STATOTROL* ADJUSTABLE SPEED DRIVE REPLACEMENT MODULES

SERIES 331X650

SUBSTITUTION OF STATOTROL MODULE: 331X650 FOR 3SRF, 3S7507RH AND 3S7507RT MODULES

GEK-47607A (8/79) 4M (F)

Figure 1. Current Limit Jumper Connections & Minimum Speed Pot Modification

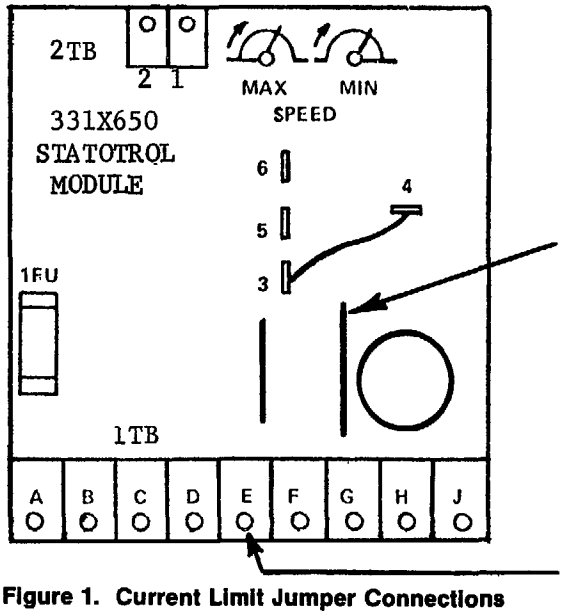
IF THE MODULE BEING REPLACED DID NOT HAVE A MINIMUM SPEED POTENTIOMETER AND THERE IS A WIRE CONNECTED TO 1TB—E ON THE OLD MODULE, THE JUMPER WIRE ON THE 331X650 MODULE CONNECTING THE MINIMUM SPEED POTENTIOMETER TO 1TB—E MUST BE REMOVED OR THE MODULE MAY BE ELECTRICALLY DAMAGED WHEN POWER IS APPLIED. SEE FIGURE 1.

The 331X650 module is a direct replacement for the 3S7507RT module. The only differences are that 2TB has two terminal points instead of five and current limit settings are made between quick-connect points 3 and 4, 5 and 6 (see Figure 1) on the printed circuit board instead of 2TB points, 3, 4 and 5. Refer to Table I for correct jumper settings for your motor.

The 331X650 module is a direct replacement for the 3SRF module. The only differences are: A) 2TB has two terminal points instead of six and the current limit settings are made between quick-connect points 3 and 4, 5 and 6 (see Figure 1) on the printed circuit board instead of 2TB points 3, 4, and 5. Refer to Table I for correct jumper settings for your motor; B) 1TB—E is electrically tied to the MIN SPEED pot and cannot be used as an external connection point unless modified per Figure 1.
